RHODE ISLAND DEPARTMENT OF TRANSPORTATION

I-195 Relocation – Contract 16 – Providence River Pedestrian Bridge

NOTICE TO PROSPECTIVE BIDDERS

ADDENDUM NO. 8 Prospective bidders and all concerned are hereby notified of the following changes in the Plans, Specifications, Proposal and Distribution of Quantities for this contract. These changes shall be incorporated in the Plans, Specifications, Proposal and Distribution of Quantities, and shall become an integral part of the Contract Documents.

DESIGNED BY:	SCALE: AS SHOWN	IMPROVEMENTS TO INTERSTATE ROUTE 195 CONTRACT 16 VOLUME 1 BOARDWALK FRAMING PLAN AND SECTION	PROVIDENCE RHODE ISLAND																		
					CHECKED: DATE: SHEET: v1_052 OF: v1_078

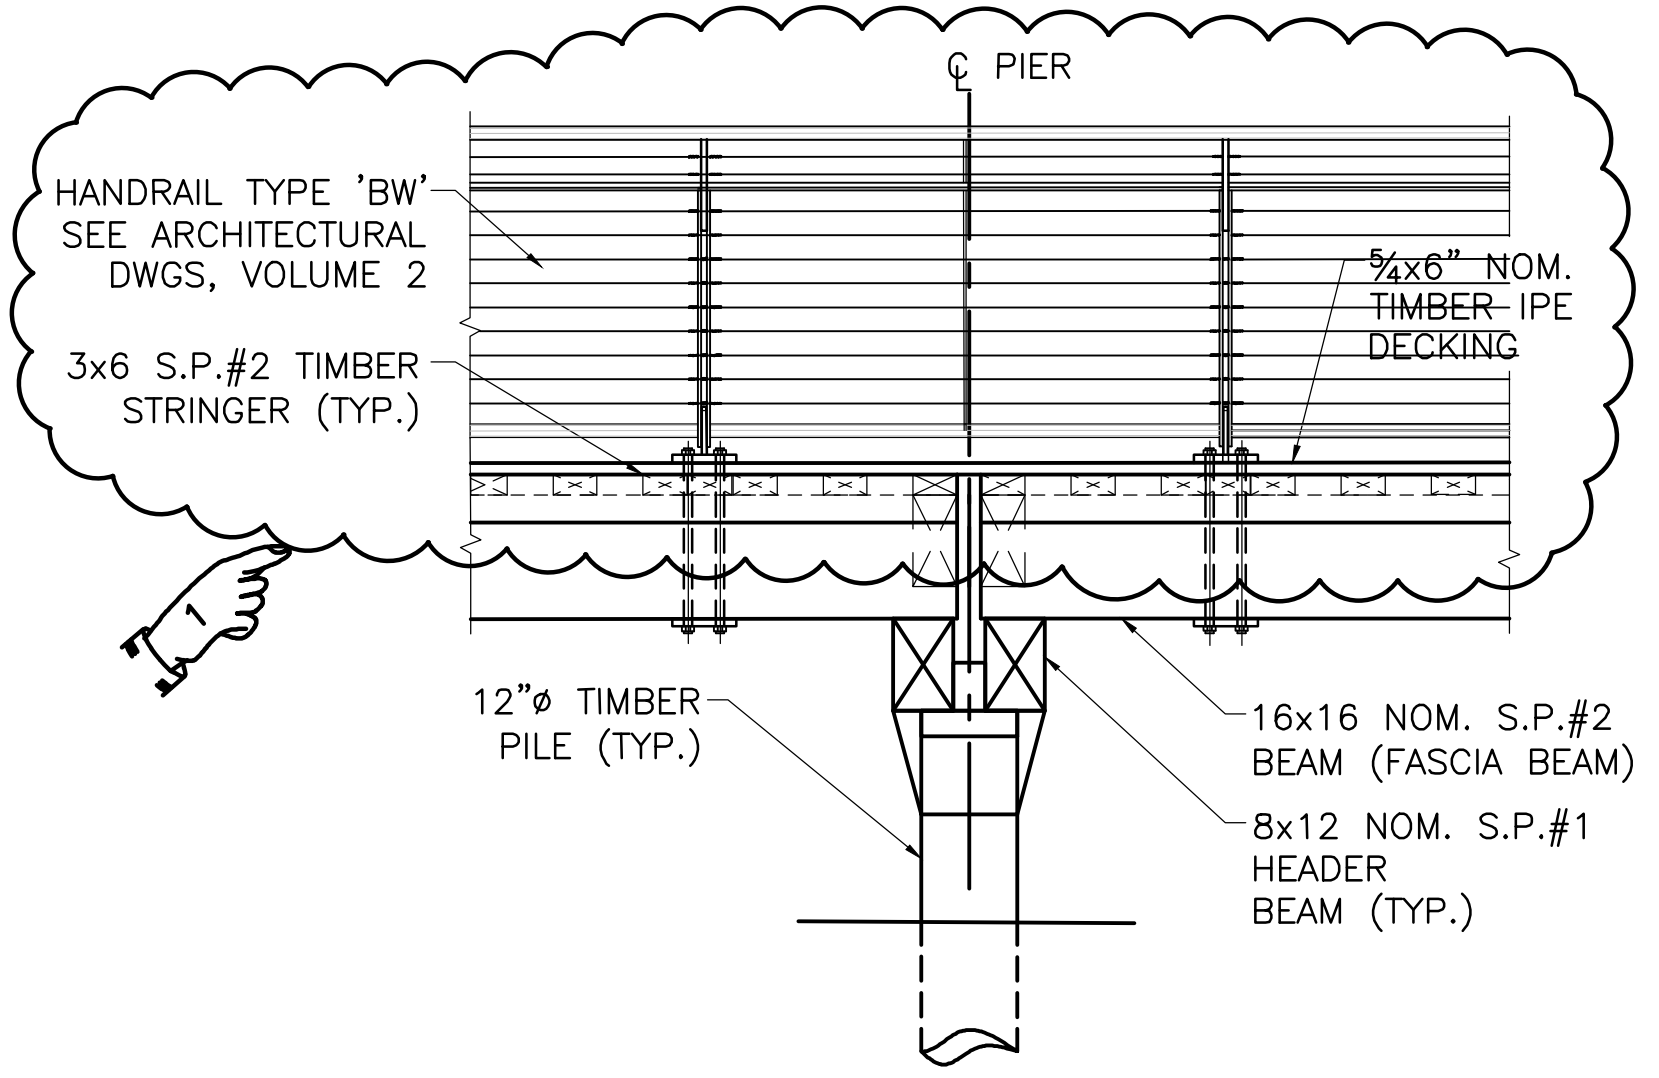
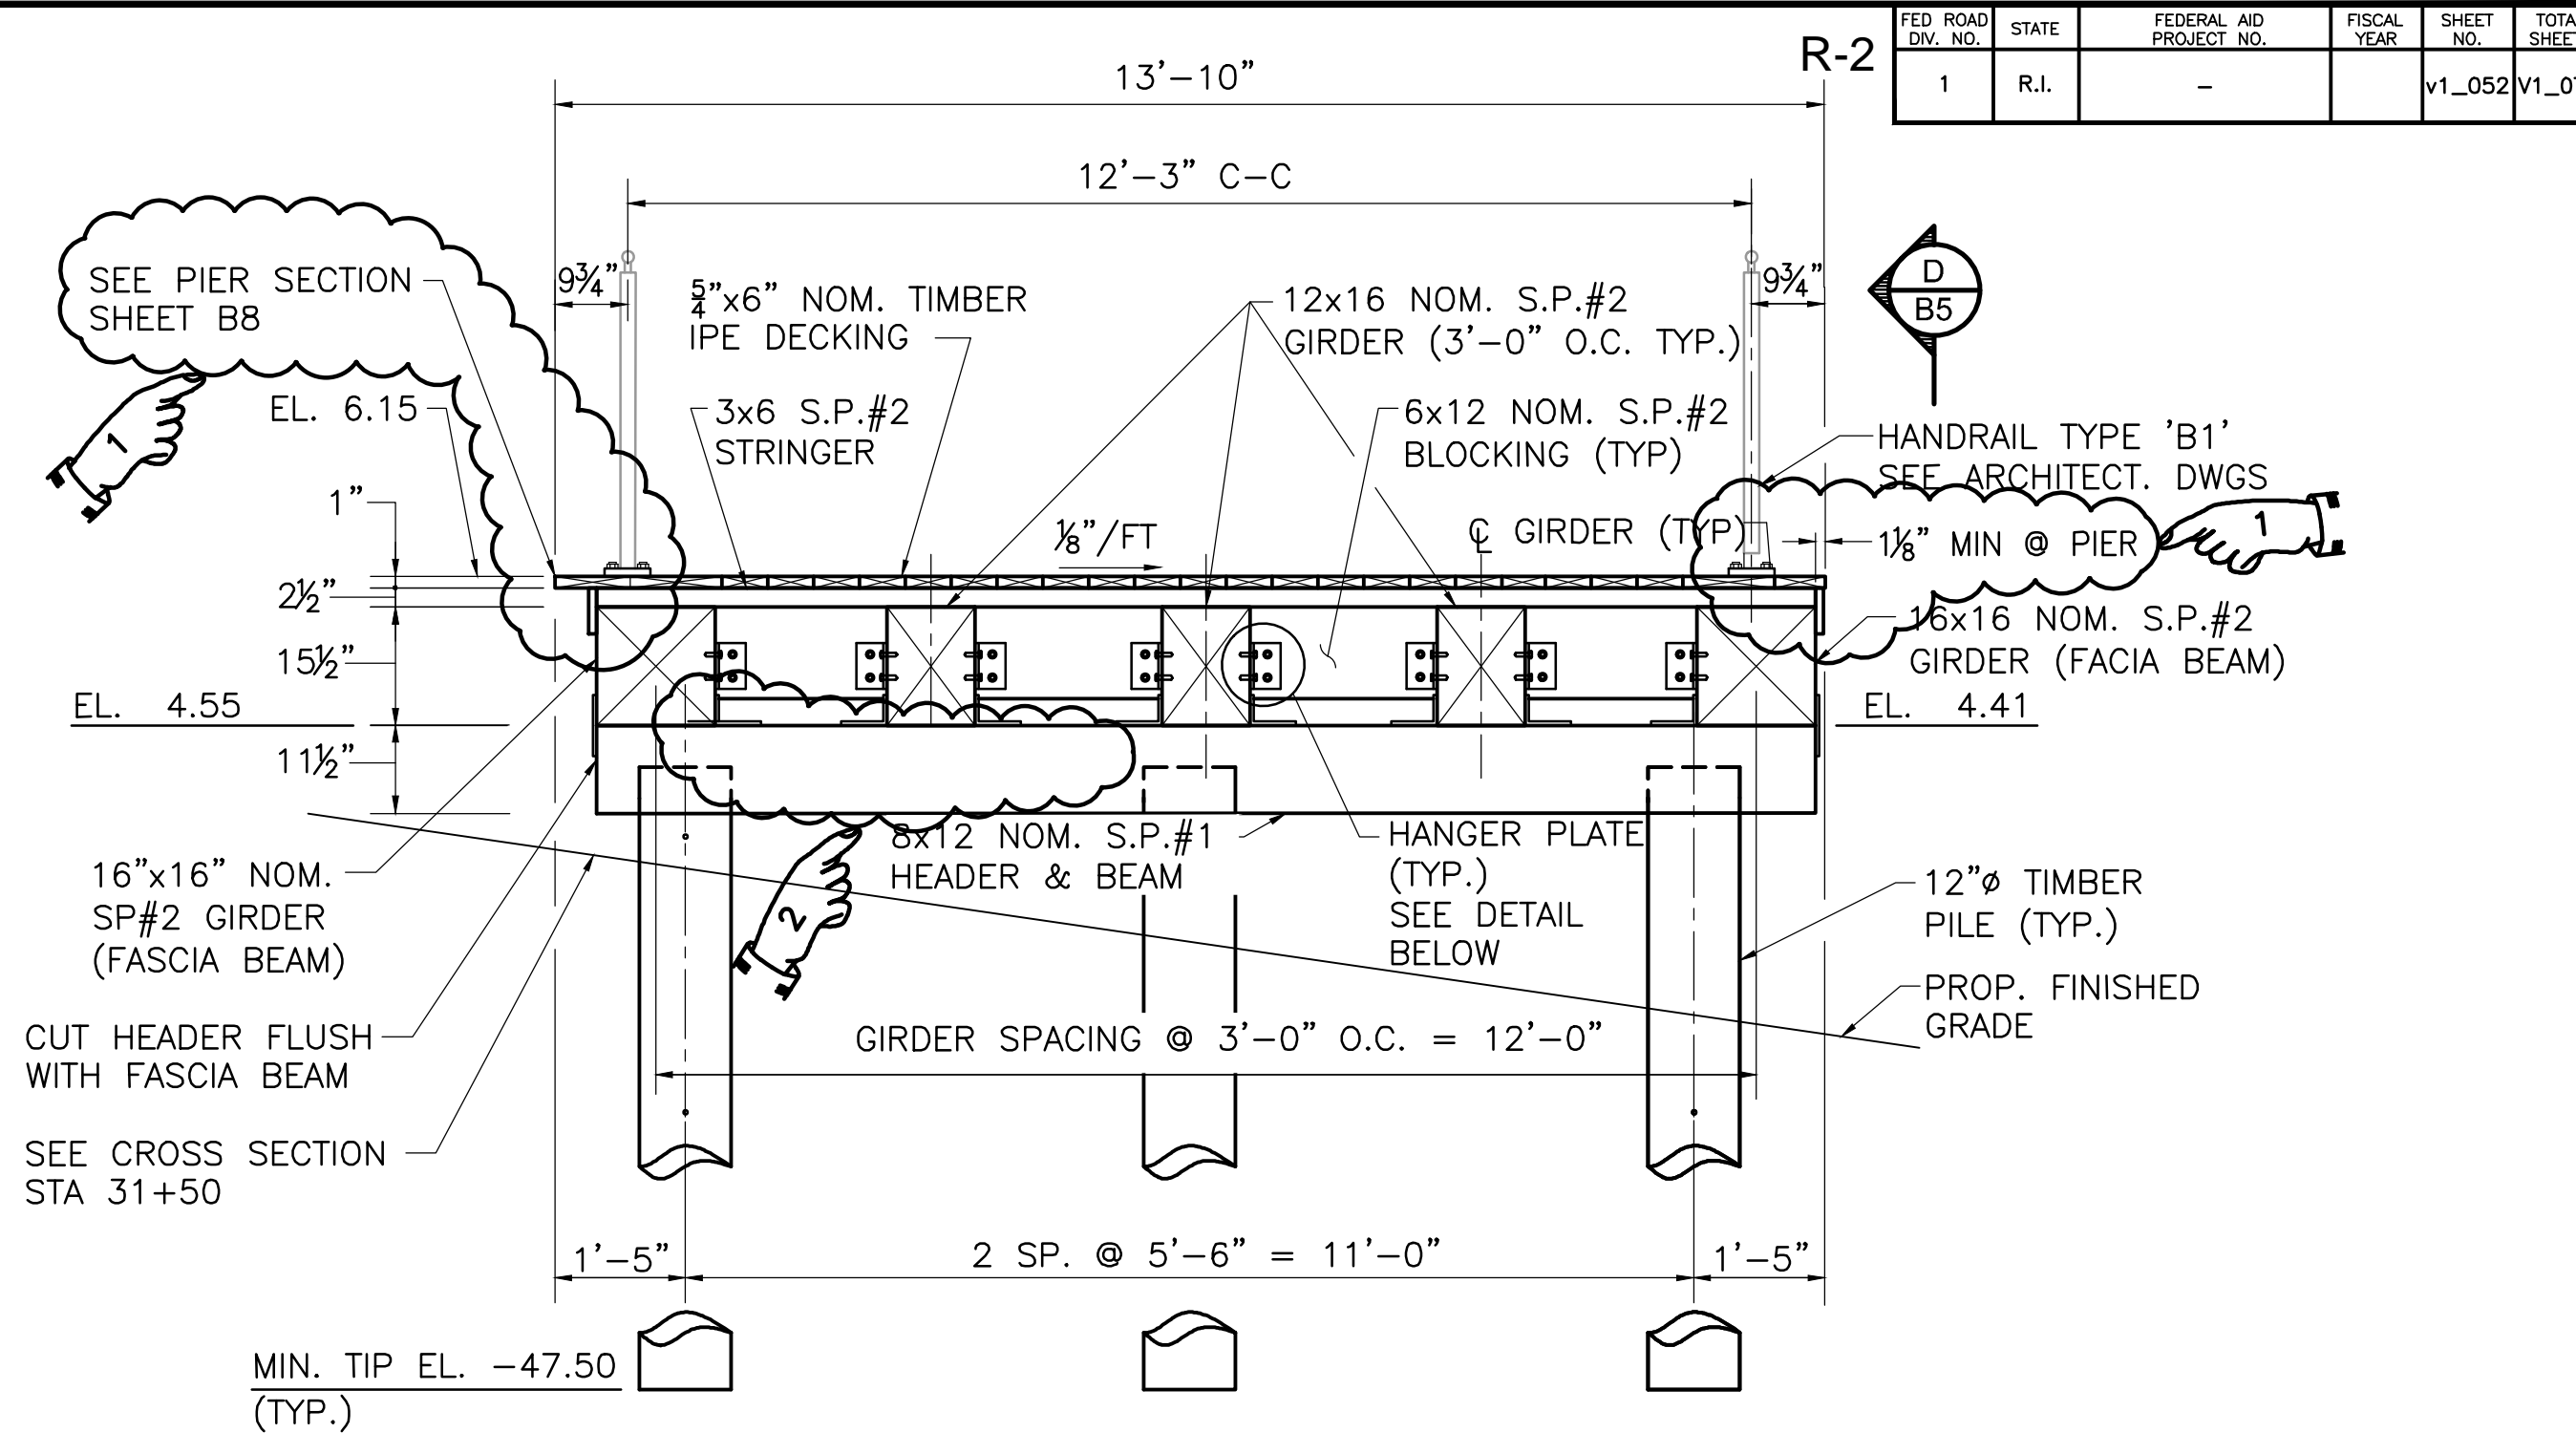
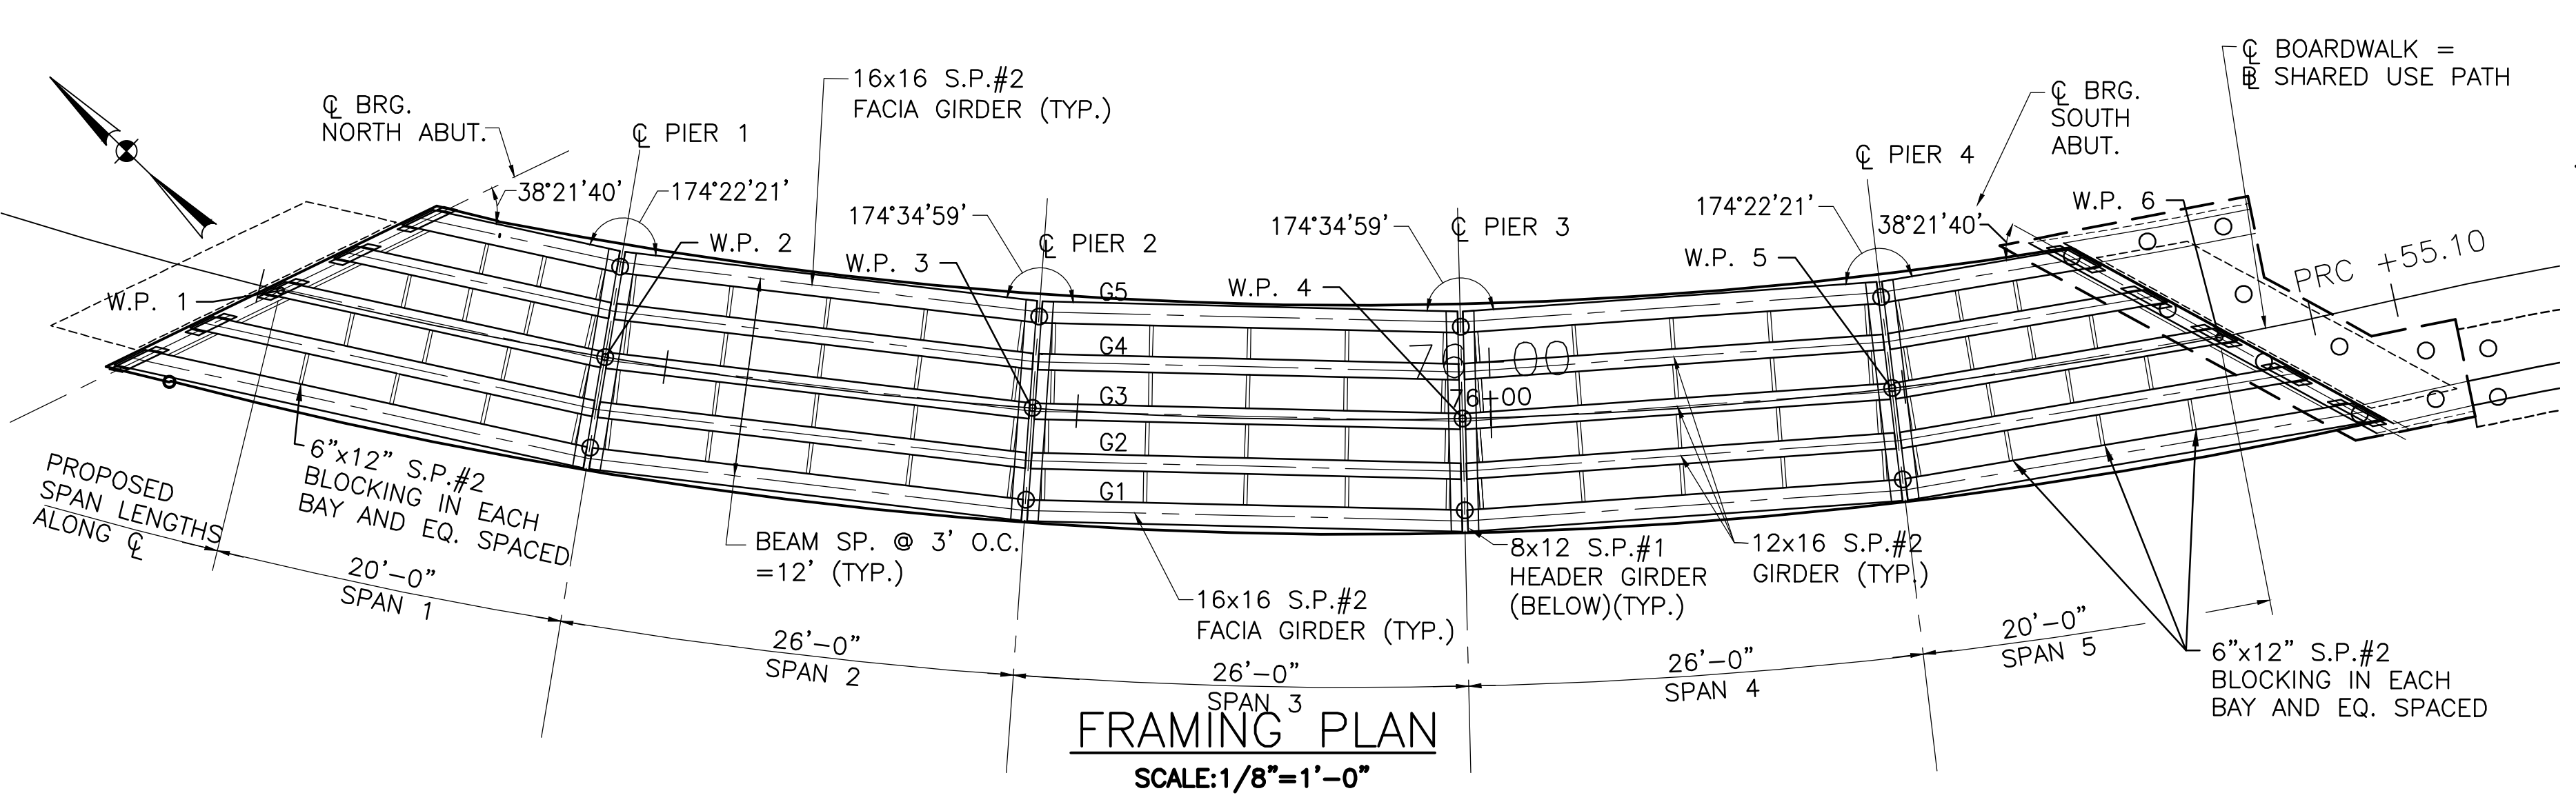
Delete Sheet V1_052(R-1) in its entirety and replace it with sheet V1_052(R-2) attached to this Addendum No. 8. The Cross section detail has been revised.
